## Report to Planning and Environment Committee

**Subject:** Sifton Properties Limited  
1938 & 1964 Commissioners Road East  
Public Participation Meeting

**Date:** September 27, 2021

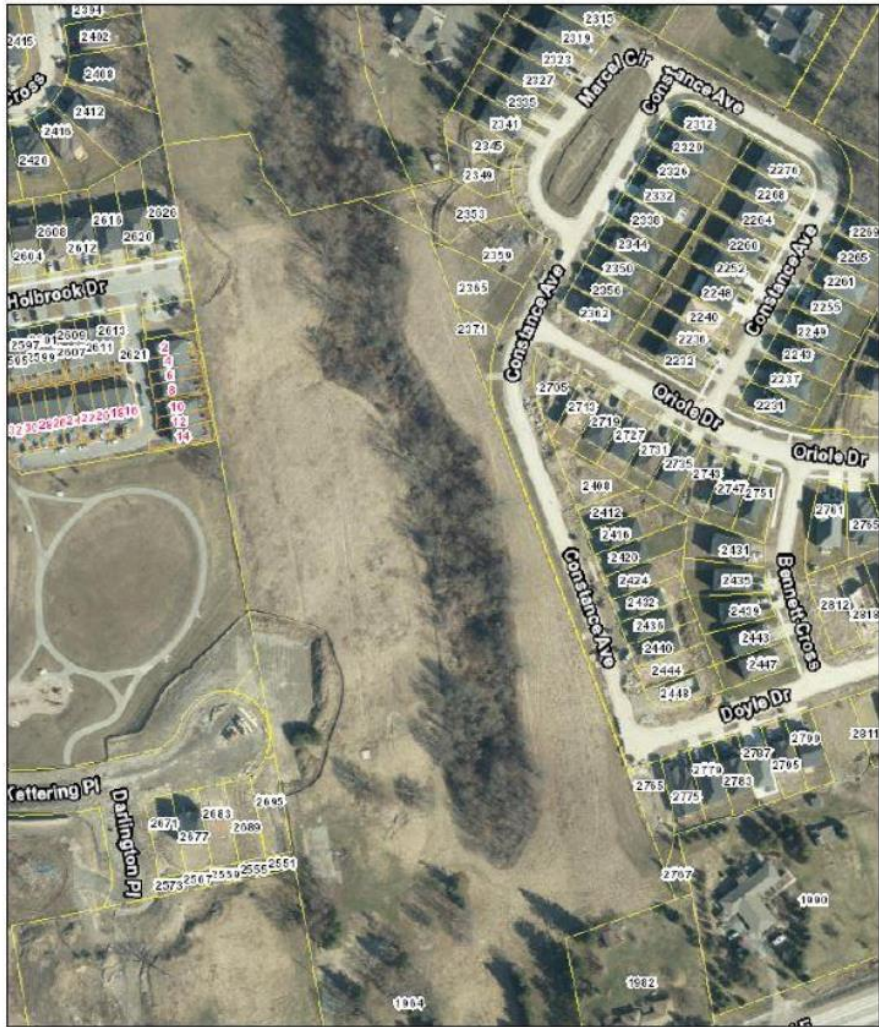
The location of the anuran call count station is not shown on any map either in the original EIS or in the revision. EEPAC also questions the date in Table 8 as it does not match the Environment Canada weather data at London Airport for the days and times listed. Also AECOM indicates in the table of comments that all three surveys were done in 2017. The EIS says the April survey was done in 2018 which is consistent with the weather data from Environment Canada for the day in question.
